Product/Process Change Notification [F-44.04]

PCN number	EU466
Issue date	2026.9.24
Submission date	2026.9.24
Change implementation date	2027.1.1
Production Site	JAE Philippines Inc
Type of change	Other (please specify)
Reason of change	Other (please specify)
Type of improvement	Other (please specify)
Change description	Change of glue additives for hot melt
Current cavities numbers / units number	N/A
New cavities numbers / units number	N/A
Affects	Material

Deviation Request Form		DR-26007	
		Part Description	MX65 series connector		
		Date of request:	Donnerstag, 24. September 2026		
		Project	MX55 series connector		
Customer Data		JAE Data			
Customer name:	TTI	JAE Requestor:	JAE Europe Ltd		
Customer site:		JAE Manufacturing Location:	JAE Philippines		
Customer contact:	Nina Sulimeenko	Manufacturing Quality contact:	Oya Yoshitaka		
e-mail address:	Nina.Sulimenko@de.ttiinc.com	JAE-EU Program Manager:	Daniel Clark		
Phone number:	49 8142 6680 - 709	JAE-EU Quality Manager	Grant Trowbridge		
Part Identification					
Part designation:	MX55A04C0015863	Supplier part number:	JAE part number(s): CBM-194392	Revision level:	
				Project code:	
Non Conformity Description					
Reason for the

耐熱性(105°C)

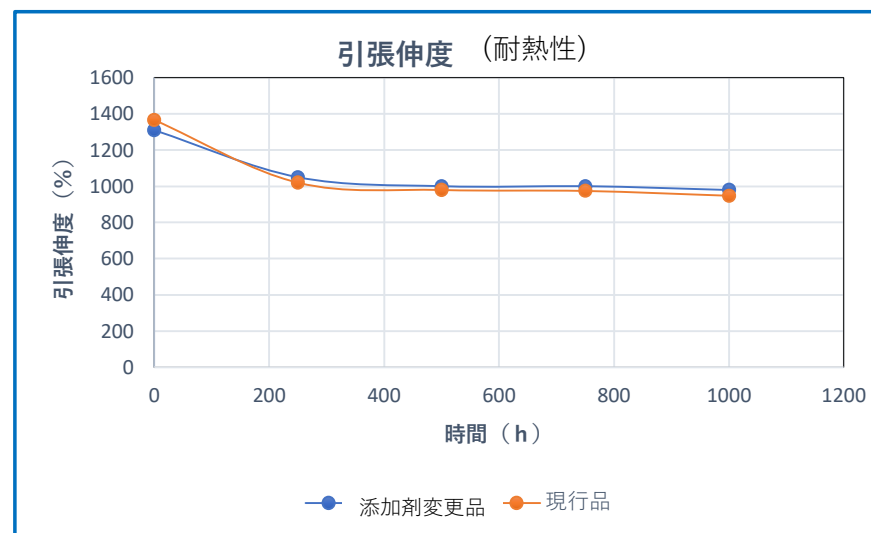
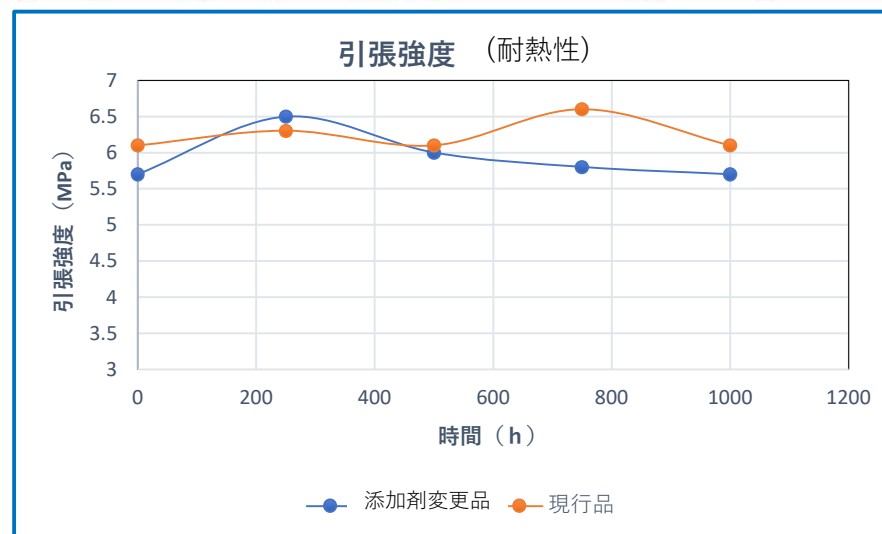
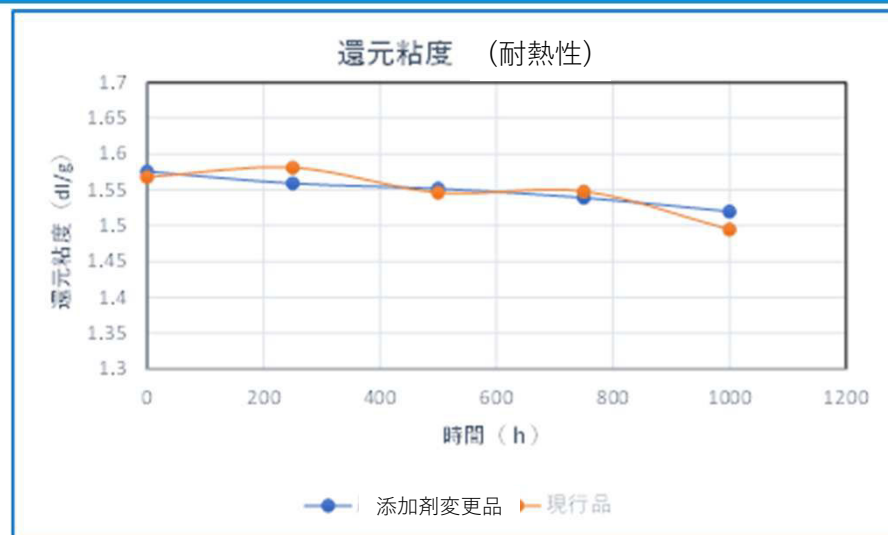
現行 GM-955-R02	新規 GM-955-R02改
添加剤処方	添加剤 A	添加剤 A
	添加剤 B	添加剤 B
	添加剤 C (廃番)	添加剤 D (代替)

※ベースポリエステルの変更はございません。

還元粘度 (耐湿熱性)

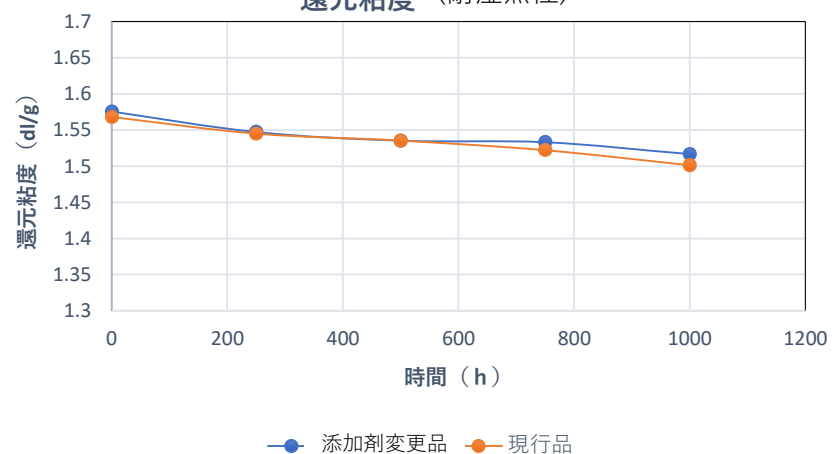
耐湿熱性(85℃×85%RH) ※グラフは弊社研究所測定値であり、保証値ではございません。東洋紡エムシー株式会社
